Tender No. : 01/CS/2014

Name of work : Supply, Instillation, Commissioning, Facility Construction & Maintenance of Drive-through Container Scanner (Road)

Subject : Clarifications to site related queries/issues raised in pre-bid meeting – JNPT, Nhava Sheva, Uran

SCHEME FOR MOVEMENT OF CONTAINERS AT PROPOSED SITE OF SCANNER FACILITY AT JNPT, NHAVA SHEVA

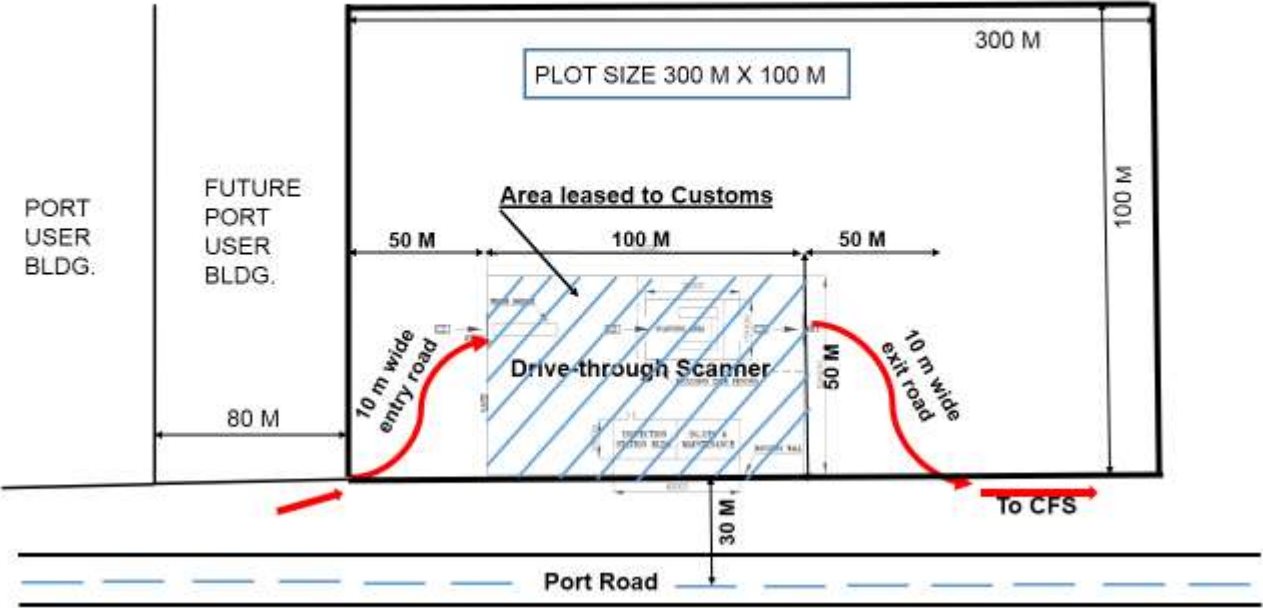
(i)	Is it possible to set up labour camp near to site or JNPT area?	Space for labour camp can be provided by JNPT on chargeable basis.
	(ii)	For men-movement any permission required?	The site is outside port area and there are no restrictions on men & material movement.
	(iii)	Any special permission required for foreign visitors?	Presently, there is no restriction for foreign nationals to visit the site.
	(iv)	Can space for temporary office / storage shed be provide outside construction area, if need be?	Temporary office and material storage yard can be set up by the Bidder in the area behind the plot.
13	Hot work' permit		
		For welding, gas cutting etc. during construction will prior permission of Port Authorities required?	No such requirement exists. However, the Bidder will need to follow site safety procedure during construction.
14	Entry & exit roads		
		Will Port authorities construct the roads leading to and from the scanner facility?	JNPT has sought that entry & exit roads be constructed by the Bidder, which will also need to be maintained by the Bidder. (Ref. Sketch below for road layout).
